TRANSMITTAL LETTER FOR NOMAD SERVICE BULLETIN

SERVICE BULLETIN NO: ANMD-55-27

Stabilisers - Horizontal Stabiliser -

Pivot Bearings and Brackets -Inspection for Side Play

FIGURE 1

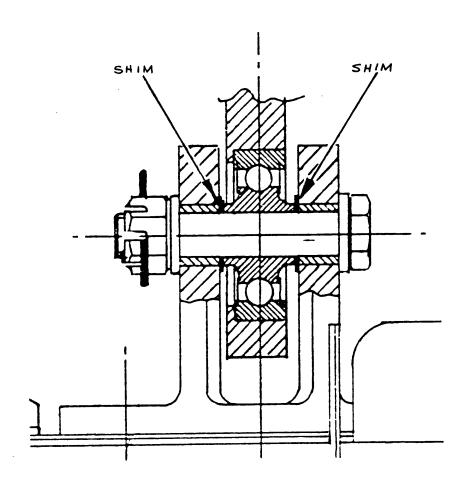
- 2. Inspect the area between each side of the horizontal stabiliser pivot bearing and the horizontal stabiliser pivot bracket for shims. Both pivot points are to be inspected. Measure across each pivot bracket with a micrometer and record readings.
- 3. Slacken off both securing nuts and measure again.
- 4. If the difference between readings is within 0.002 inch, shimming is acceptable. Tighten pivot bolt nuts finger tight and install split pins.
- 5. If the difference between readings is between 0.002 inch and .010 inch, shim in accordance with Para 2.B. of this service bulletin.
- 6. If the difference between readings is in excess of 0.010 inch, advise ASTA of the reading and await engineering advice.

- B. 1. Install shims as required between the pivot bearings and the horizontal stabiliser pivot brackets to give between 0.000 and 0.002 inch end float of the horizontal stabiliser. Shims should be equally distributed between both pivot bearings.
 - Tighten the pivot bolt nuts finger tight and install split pins.
